Product	Concord 4 with external receiver.
Date	January 5, 2007

Issue

GE Security has identified a software issue with version 4.01 and 4.02 Concord 4 panels when used with an external receiver or external transceiver. Wireless devices appear to be properly learned into the panel via external receivers or transceivers, however zones learned into them do not produce alarms at the panel or to the central station.

Figure 1. Bar code label location

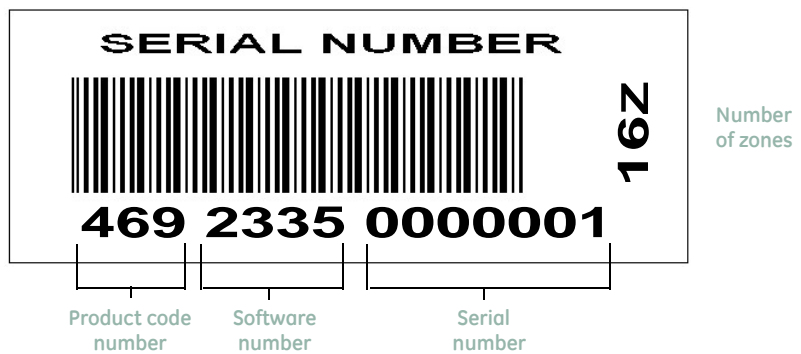
Bar code label

Locate the bar code label on the panel circuit board (*Figure 1*).

Panels with software version 4.10 and above contain changes that GE Security implemented in late December 2006. You can use the bar code label on the Concord 4 circuit board to identify the newer firmware (see *Bar code label* on page 2).

Figure 2. Bar code label number

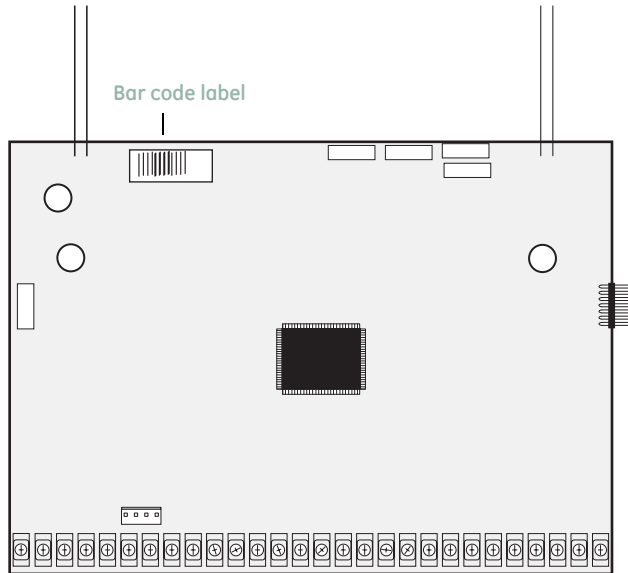
Use the bar code label serial number (*Figure 2*) to identify version 4.10 Concord 4 panels.

The product code and software numbers for version 4.10 Concord 4 panels will be:

- 469 2335 (Concord 4 Residential)
- 491 2336 (Concord 4 Commercial)
- 504 2337 (Concord 4 Monotronics)

Any other product code and software numbers will indicate versions 4.01 and 4.02 Concord 4 panels.
